Marmalade Lane

Proposed Development & Amendments to
Permitted Residential Development
ABP-312170-21

Applicant's Response to LRD Opinion

MLD-1-XX-SW-XXX-RP-DOB-CE-000003

Figure 1 Comparison of permitted and proposed amended surface water network

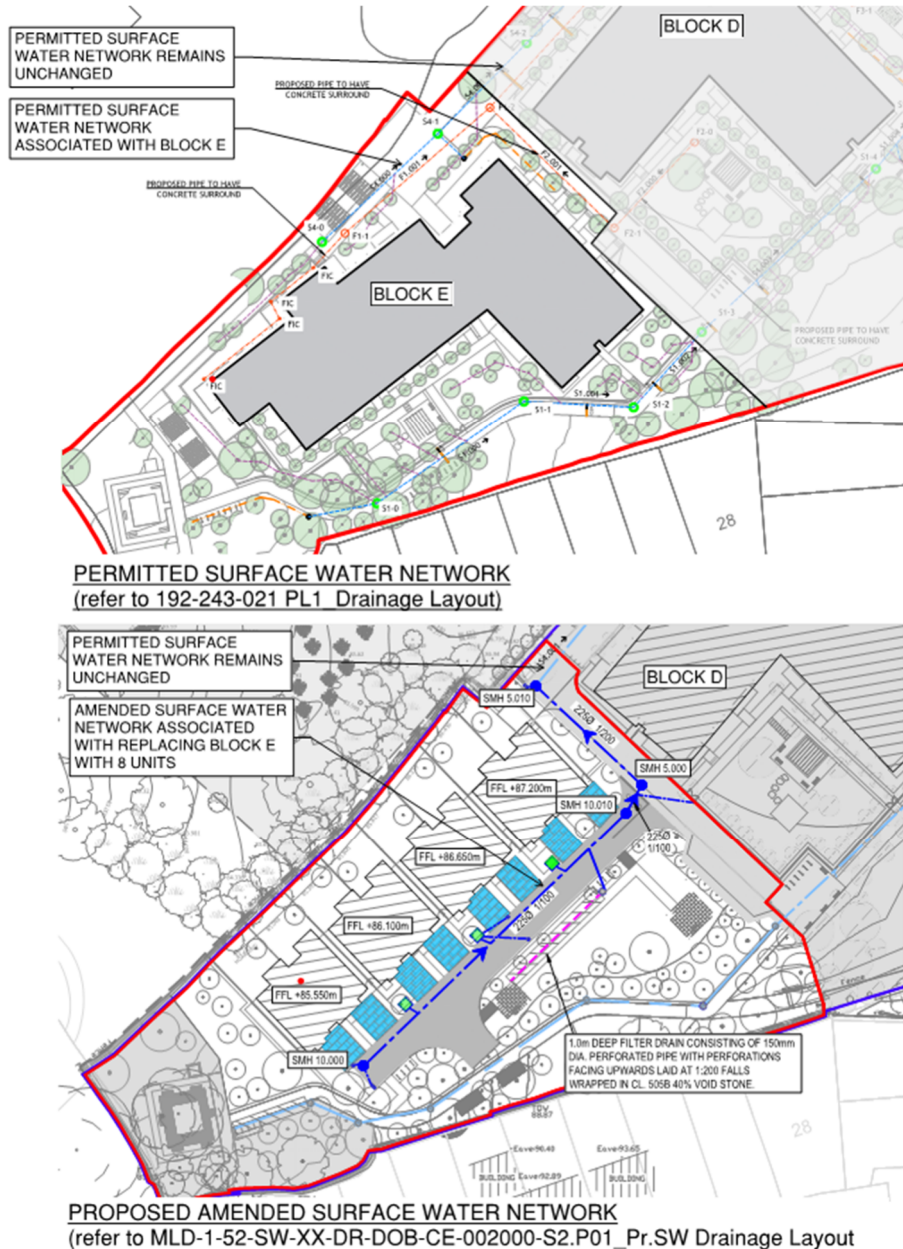
The Planning Authority requested clarity on how the proposed amendment would integrate with the permitted drainage scheme, particularly regarding outflow and positively drained areas. In response, the applicant submitted updated documentation confirming seamless integration and an increase in positively drained areas due to expanded public open space. An updated Site-Specific Flood Risk Assessment (SFRA) was also provided, confirming no flood risk on-site or off-site. The Authority was satisfied that flood flow paths remain unobstructed and unaffected by the proposed changes. Any future stage LRD 3 application should include evidence to demonstrate that the proposed drainage infrastructure for the proposed development and the Site-Specific Flood Risk Assessment (SSFRA) is carried out in accordance with the requirements of the Dun Laoghaire Rathdown County Development Plan 2022-2028. Please refer to Appendix A Drainage Planning Report for detail on what is required to be submitted.

The permitted surface water drainage system granted under ABP-312170-21 remains unchanged, save for the amendments related to the surface water network located to the south-west of the subject site associated with the proposed 8 units replacing Block E as illustrated in Figure 1 below.

The table below provides a comparison of the hardstanding area in relation to the proposed amended planning application and the original granted planning application. Please note that this only relates to the southwestern corner of the site identified as the amendment in Figure 1.

We would further note that the original granted planning application indicated an attenuation requirement for the catchment relating to the amended planning application is 250.9m³. The amended planning application, which includes the updated positive draining areas as mentioned in Table 1, has been simulated using Microdrainage software. The results of the amended planning application simulation indicate that the storage as provided in the granted application of 250.9m³ is sufficient. There is therefore no additional storage provision required for the proposed amended planning application. The following table provides the integration between the proposed and granted scheme, indicating that no changes are required.

Figure 2 Comparison of permitted and proposed amended wastewater network

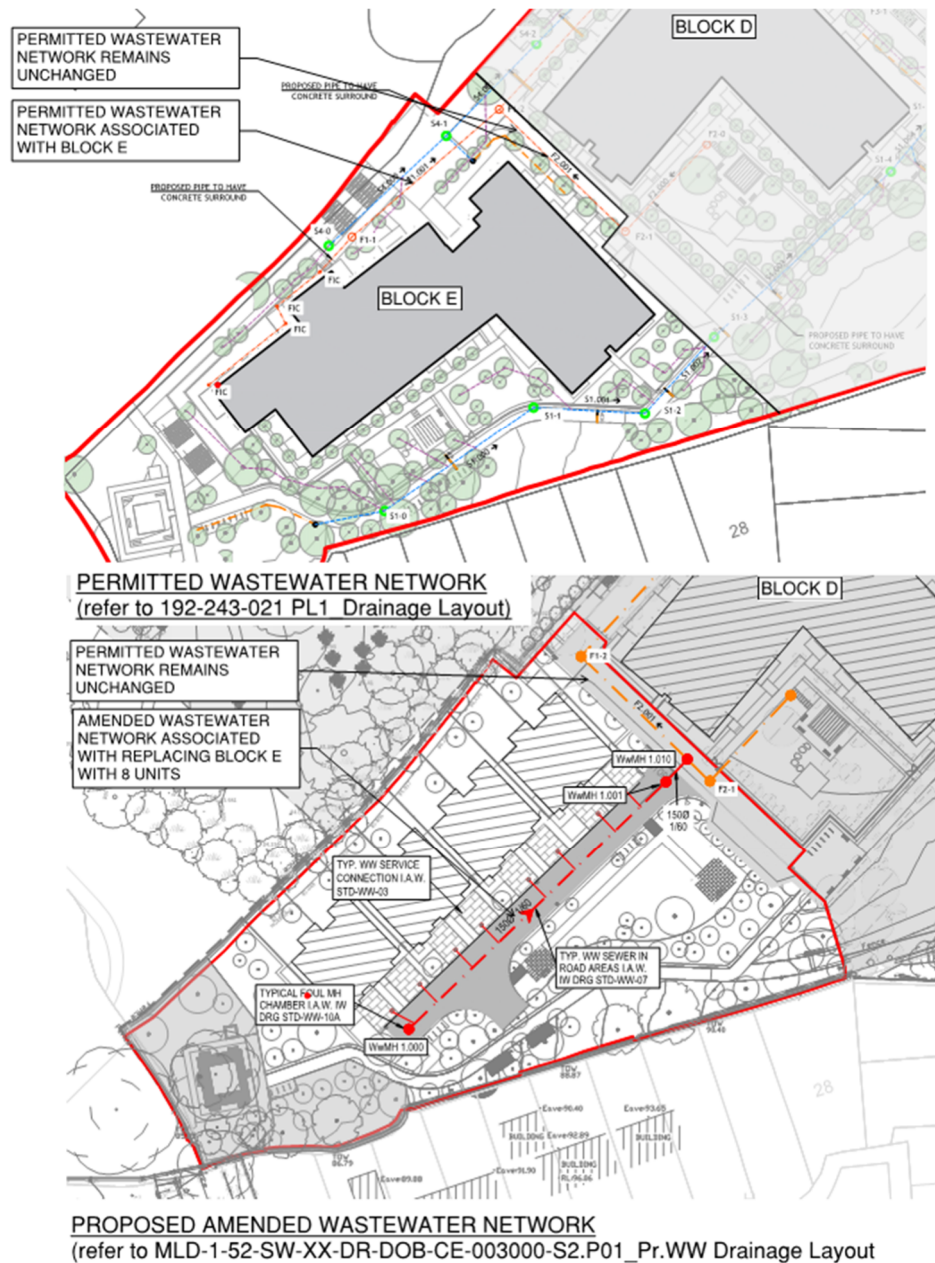
From the Planning Authority's perspective, the applicant is advised that any future application should continue to demonstrate how the proposed development integrates with existing water and wastewater services. This should include confirmation from relevant service providers, such as Irish Water, that adequate capacity exists to accommodate the revised scheme, and that no adverse impacts on service provision will arise.

The permitted wastewater drainage system granted under ABP-312170-21 remains unchanged save for the amendments related to the wastewater network located to the south-west of the subject site associated with the proposed 8 units replacing Block E as illustrated in **Figure 2** below. The proposed wastewater infrastructure associated with the amended development will connect to the wastewater currently being constructed in accordance with Uisce Eireann Connection Agreement CDS2400627001. Overall, the peak wastewater discharge for the whole development will be reduced to 13.25 l/s from the permitted discharge of 14.93 l/s. The reduction in wastewater discharge arises from replacing Block E with the proposed 8-unit amendment.
